TOWN OF KENT INLAND WETLANDS COMMISSION

REGULAR MEETING MINUTES

RE: Site Plan Review – Response to Anchor Engineering Review of May 18, 2016 South Kent School Multi Use Athletic Field Bulls Bridge Road, Kent, CT

South Kent Project Topsoil Relocation

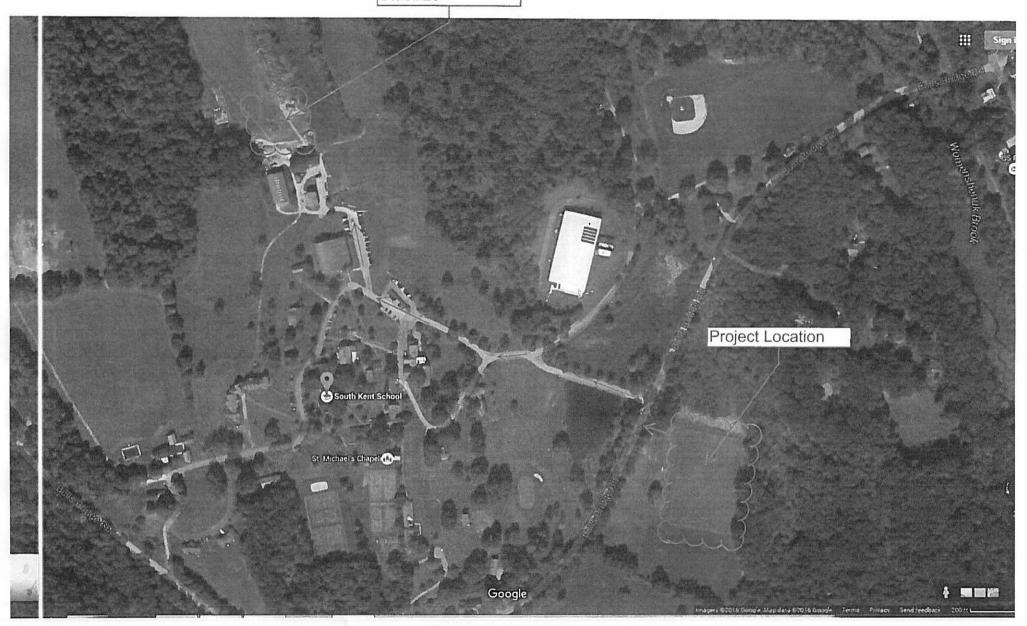
4. Proposed soil stockpile areas should be shown and the "limits of disturbance" adjusted if necessary. Erosion control measures for the stockpiles should be included.

Soil will not be stockpiled onsite. All topsoil that is stripped will be removed from project site and relocated to another location on campus where it will be graded and stabilized. Any topsoil required to restore "lawn areas" around the turf field will be brought back and placed. A diagram of the movement of the soil to it's new location is attached.
